Model: Martini-C3.5	Date: 07-Feb-08	No.: RD052001a
----------------------------	-----------------	----------------

Subject: Firmware Release Note: Engine		Prepared by: S.Watanabe	
From: 2nd Tech. Support Sec. Service Support Dept.			
Classification:	<input type="checkbox"/> Troubleshooting	<input type="checkbox"/> Part information	<input type="checkbox"/> Action required
	<input type="checkbox"/> Mechanical	<input type="checkbox"/> Electrical	<input type="checkbox"/> Service manual revision
	<input type="checkbox"/> Paper path	<input type="checkbox"/> Transmit/receive	<input type="checkbox"/> Retrofit information
	<input checked="" type="checkbox"/> Other ()

Model: General		Date: 12-Mar-08	No.: RGene027
Subject: New Wireless LAN Option		Prepared by: H.K.	
From: 1st Tech. Support Sec. Service Support Dept.			
Classification:	<input type="checkbox"/> Troubleshooting <input type="checkbox"/> Mechanical <input type="checkbox"/> Paper path <input type="checkbox"/> Product Safety	<input type="checkbox"/> Part information <input type="checkbox"/> Electrical <input type="checkbox"/> Transmit/receive <input type="checkbox"/> Other ()	<input checked="" type="checkbox"/> Action required <in

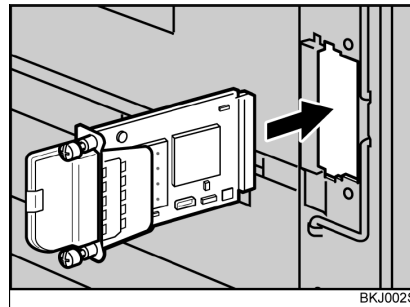
Previous types:
PCB, LAN card, and cover are
separate

New Type (IEEE802.11b
Interface Unit Type N):
Pre-assembled

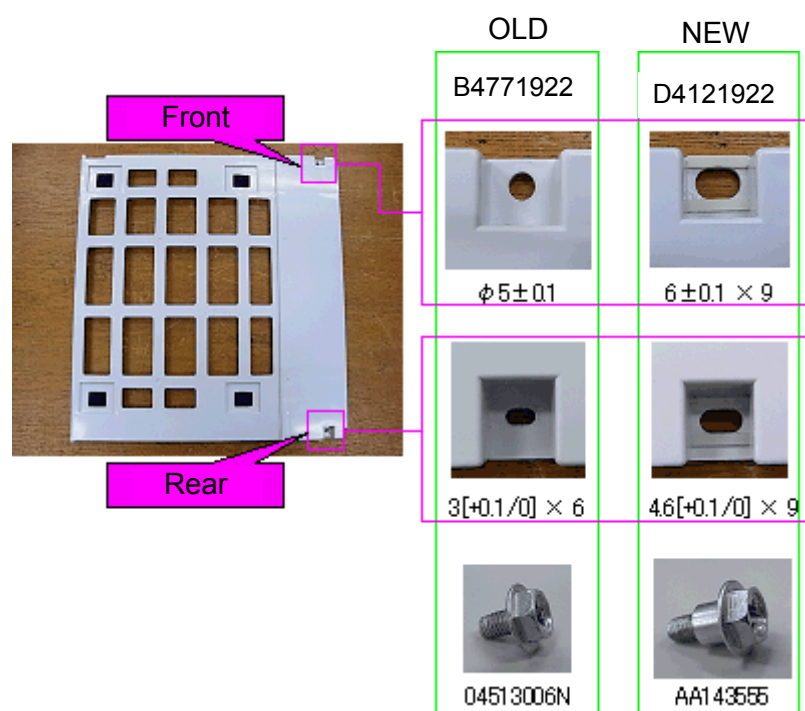
Change: The shape of the screw holes in the lower cover was changed.

Reason: To further minimize curving in the cover.

Location of decal

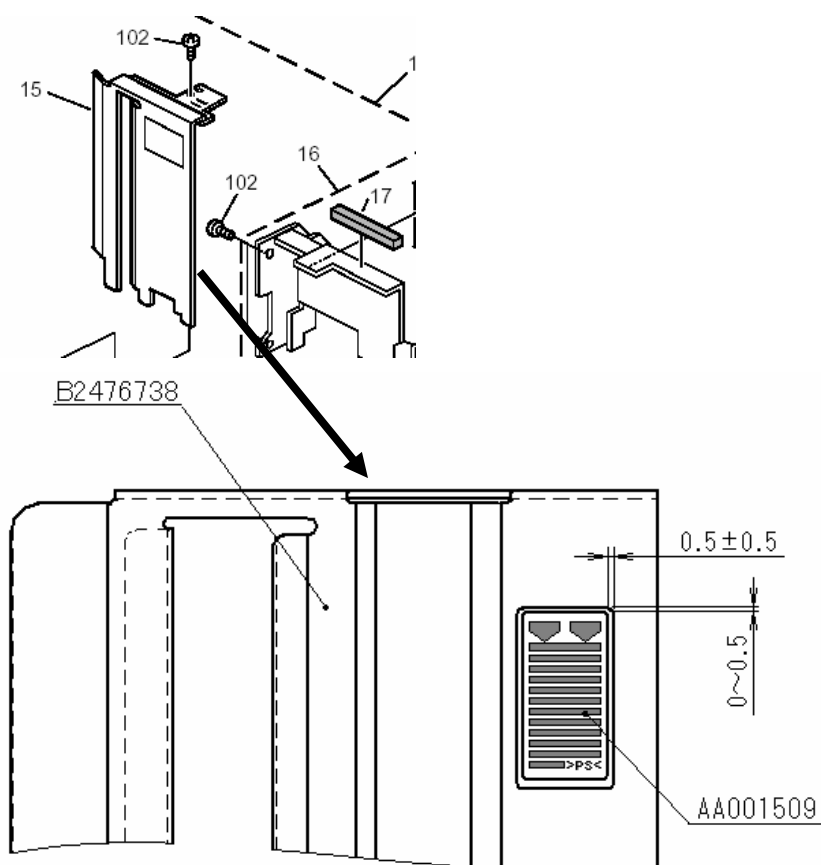
Change: A decal was added to the side fence.

Reason: To further improve the usability of the side fence.

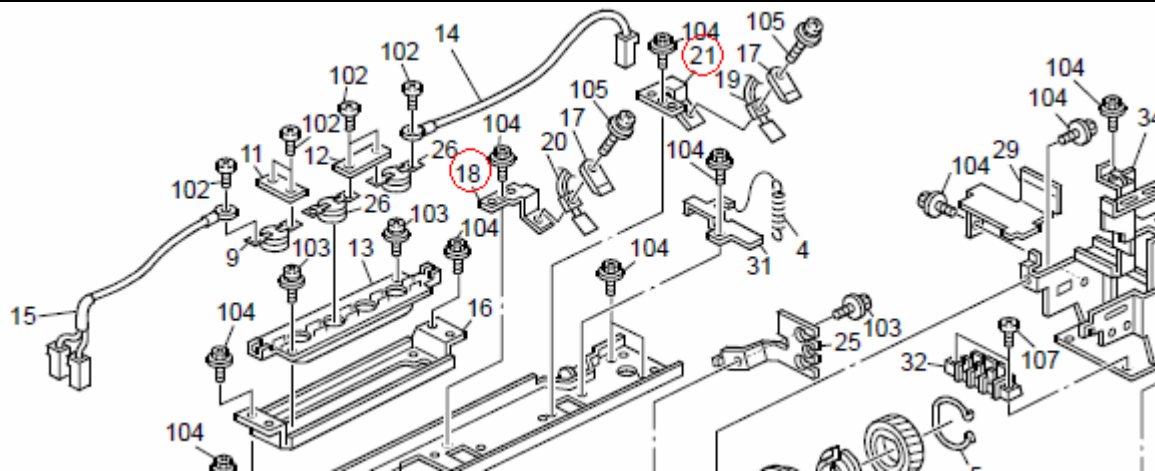
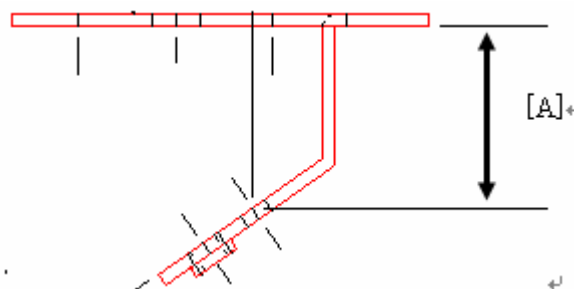
The distance [A] is different between the new and old brackets .

B1404196/7: 14.8mm

D0624196/7: 15.3mm

1. Clean the middle and rear thermistors.
2. If the SC still occurs even after cleaning the thermistors, replace the thermistor brackets with the new parts in the table below.

Note: This will secure the thermistors in the correct position, ensuring that they can detect the roller temperature correctly.

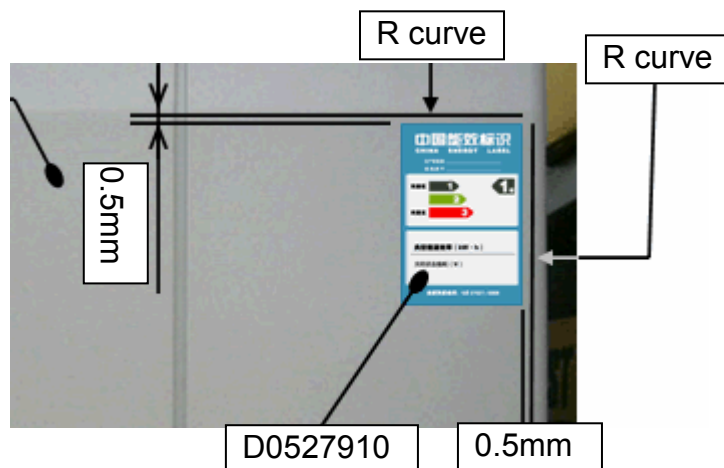
Change: The “China Energy Label” was added as a service part.

Reason: To make it possible to replace the label in the field.

Location of decal

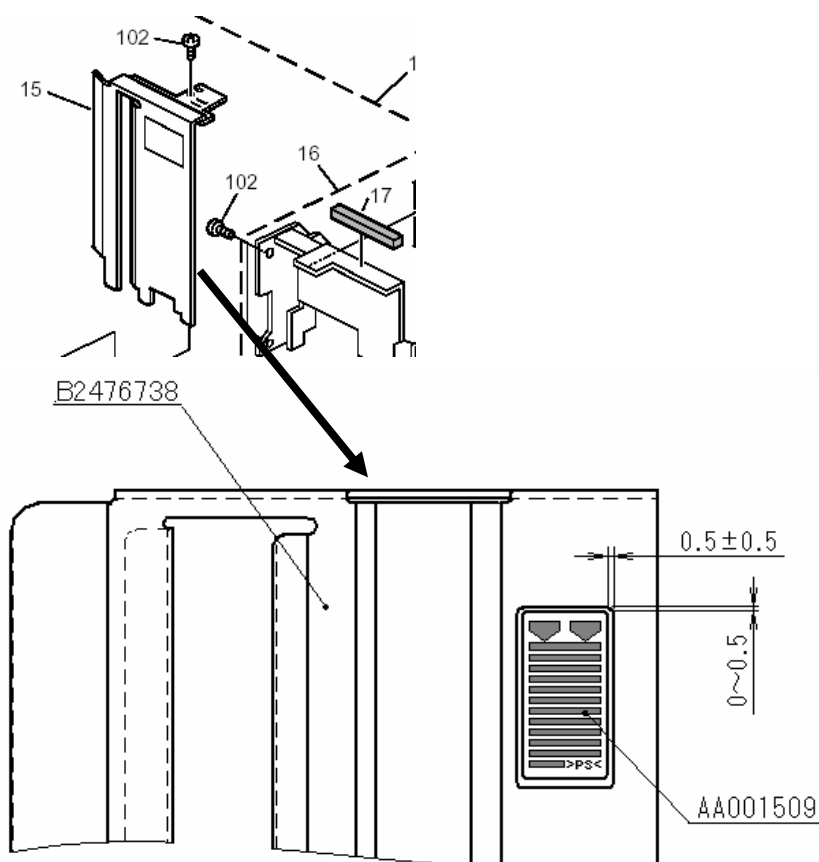
Change: A decal was added to the side fence.

Reason: To further improve the usability of the side fence.

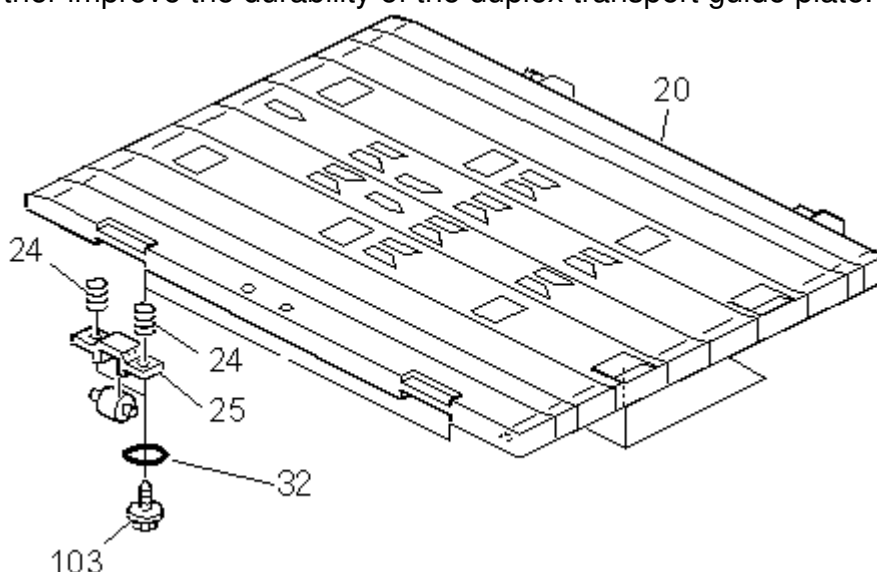
1. The thickness of the duplex transport guide plate was increased.
2. The diameter of the spring was increased.
3. A spacer was added.

Reason: To further improve the durability of the duplex transport guide plate.

3.Operation Panel (D052/D053/D054)

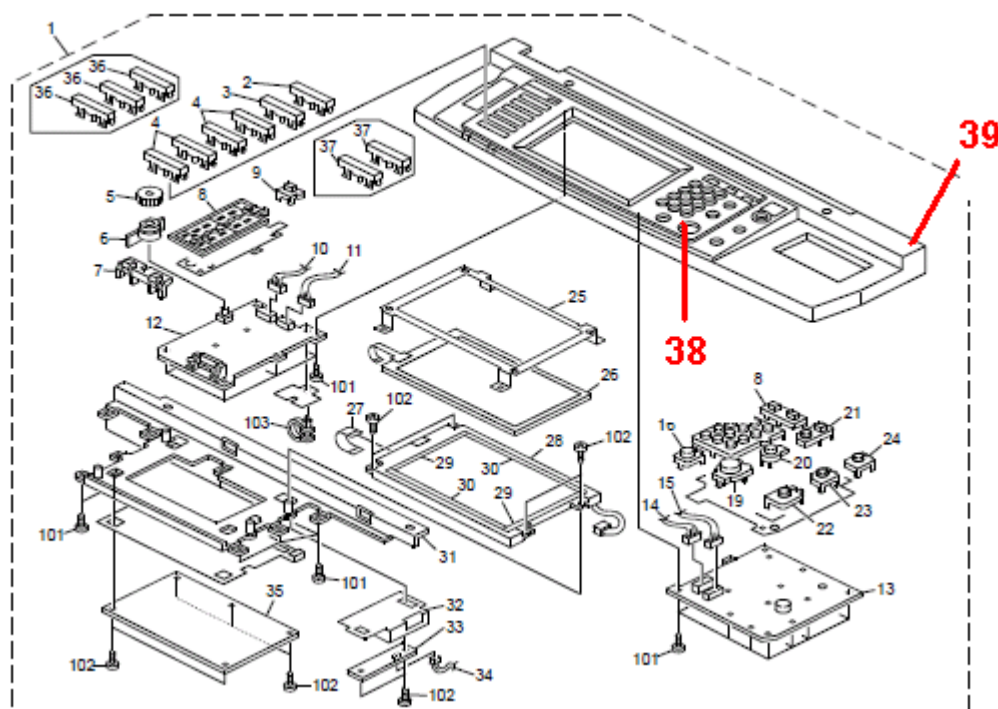
As per field request, the following part was newly added as a service part.

New part number	Description	Target model	Q'ty	Page	Index
B2231561	PANEL:UPPER:NA	D052/D053/D054-17/29/57	1	19	38
B2231562	PANEL:UPPER:EU	D052/D053/D054-27	1	19	38
B2471440	COVER:UPPER:M-C3:NA	D052/D053/D054-17/57	1	19	39
B2471470	COVER:UPPER:M-C3:EU	D052/D053/D054-27	1	19	39

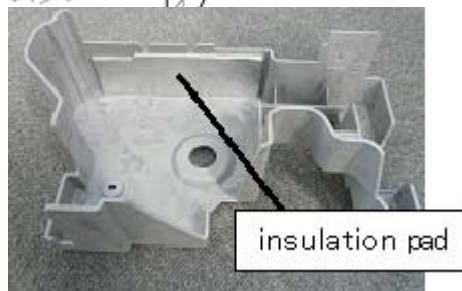
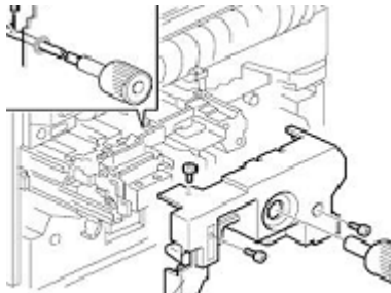
3. Attach the extra insulation pad (B0654255).

Note: This will prevent heat from being transferred from the fusing unit to the toner bottle.
